**RE: Coronado Village – Water Tank
Grading and Drainage Plan
Stamp Date: 11/21/17
Hydrology File: C18D017**

**RE: CORONADO VILLAGE-WATER TANK
GRADING AND DRAINAGE PLAN
STAMP DATE 11/16/17
HYDROLOGY FILE: C18D017**

NEW STORAGE TANK
GRADING PLAN

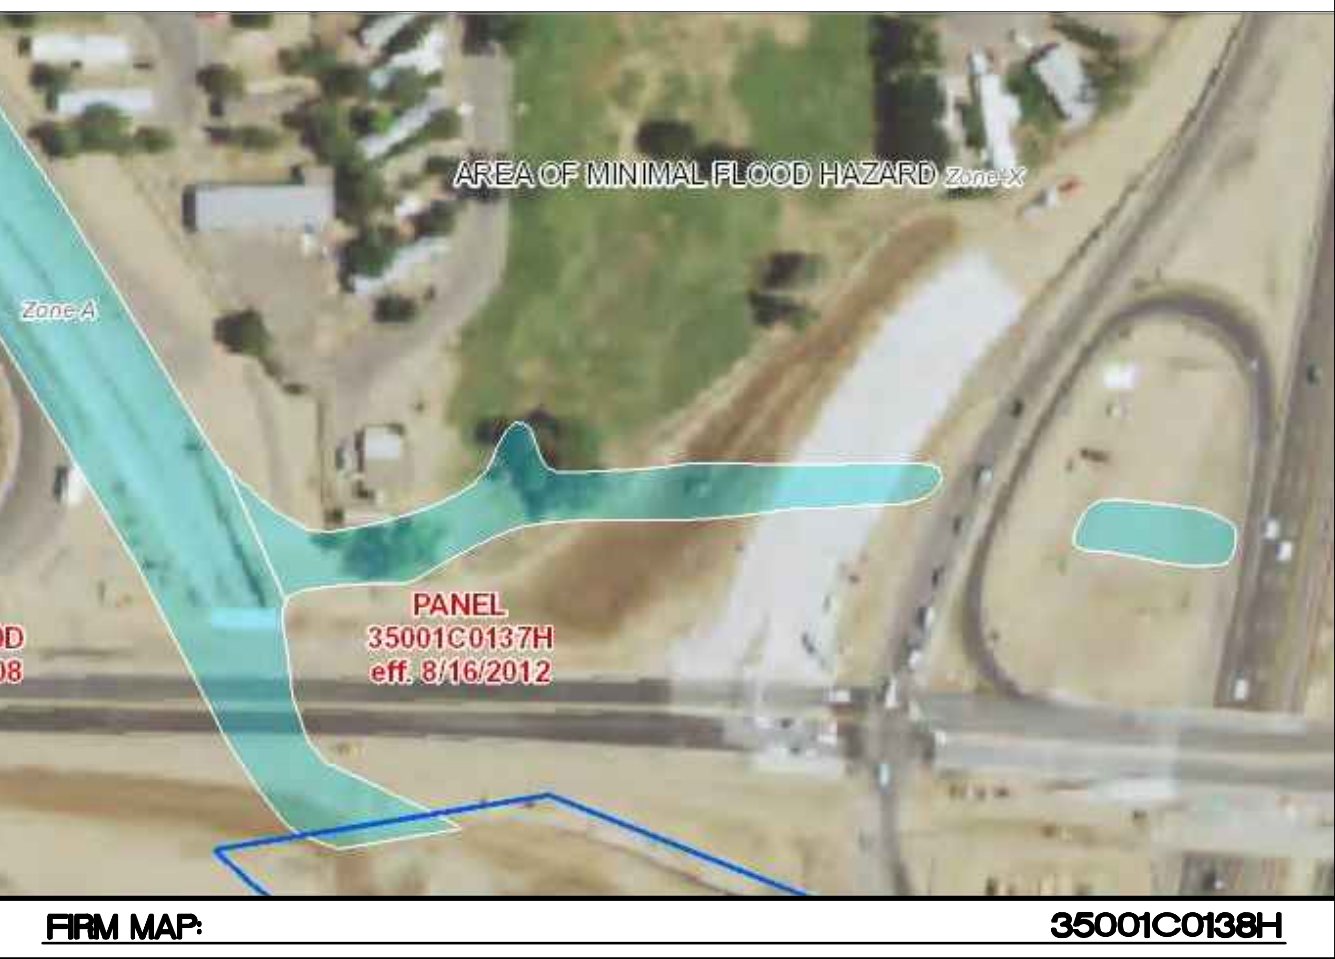
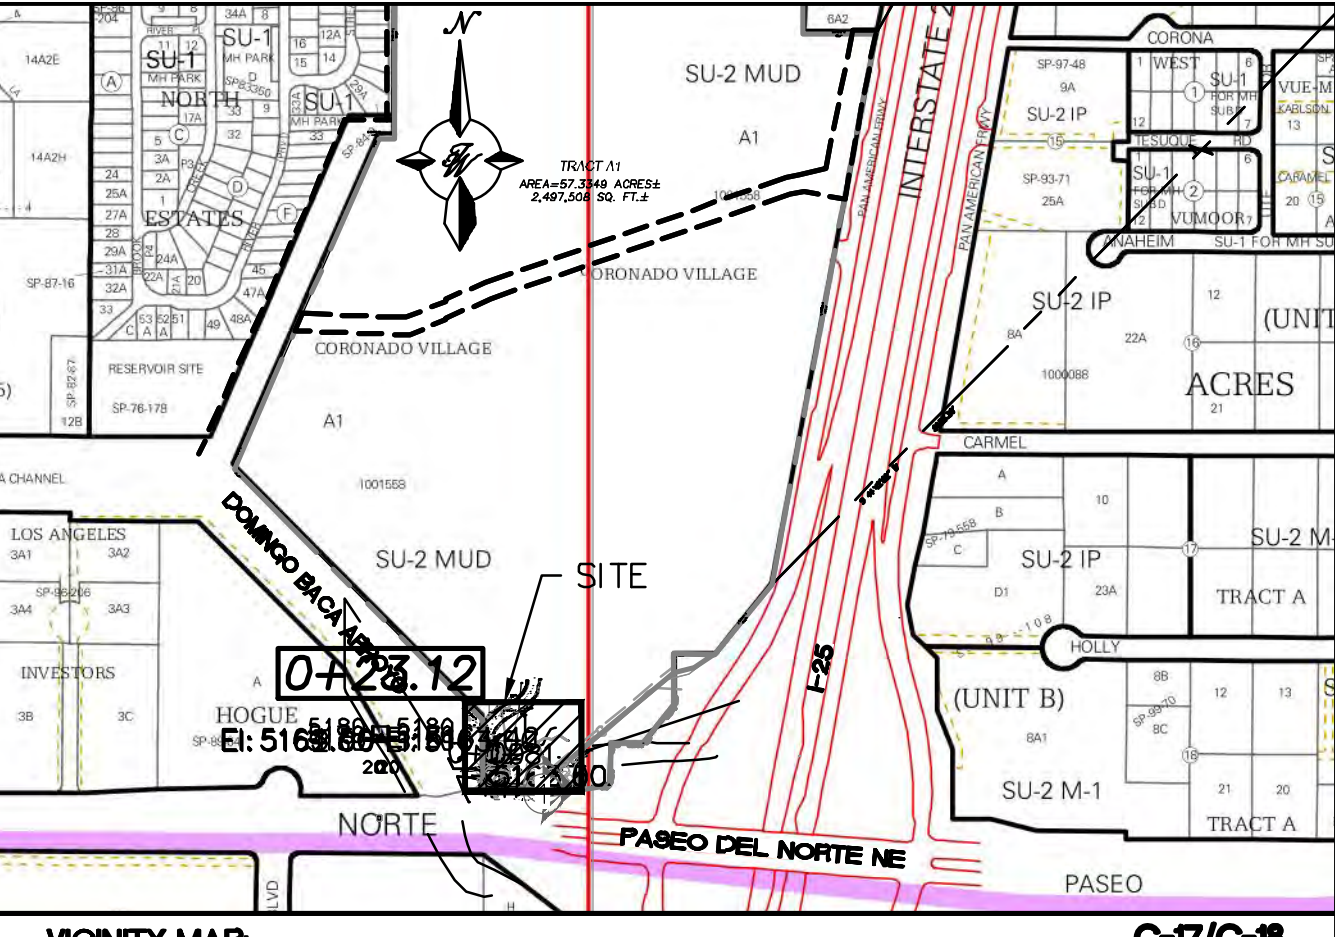
1. Please show and label the flood plain "AO" on the Grading Plan.
The flood plain as it is currently shown on the FIRM map is identified on the Grading Plan

2. Please provide the benchmark information for the survey contour information provided.
The benchmark information is now shown on the Grading Plan.
3. Please relocate the first flush pond. It needs to be directly downslope of the proposed tank so that the runoff goes into it prior to running down the concrete channel rundown to the North Diversion Channel.
We would agree with this statement under normal circumstances, however because this is a water tank the New Mexico Environmental Department will not allow a pond next to the tank. To account for the amount of water that needs to be retained we proposed a first flush pond at the end of the roadway that does drain to the same location as the tank and would retain the same amount of flow that is required.

4. Please either relocate the proposed new tank out of the "AO" flood plain or raise the pad elevation one foot above the 100 year elevation for this "AO" flood plain. This 100 year elevation may have to be calculated.
We have added a Basin Map to the Sheet showing the area that drains to the channel. This area generates a total 100 yr flow of 12.63 cfs. Without the tank in that location that would amount to a depth of 0.19 feet which does not meet the definition of a flood plain. However the tank elevation is one foot above that elevation at that specific location

5. If the location of the proposed new tank is to remain, then please create a diversion swale around the tank to allow the existing runoff flow the concrete channel rundown to the North Diversion Channel and not have the proposed new tank be a blockage for the existing drainage flow.

As mentioned above the amount of flow around the tank is 12.63 cfs. As shown on the cross-section there is room for all of that water to travel around the tank and only obtain a depth of 0.50 feet.
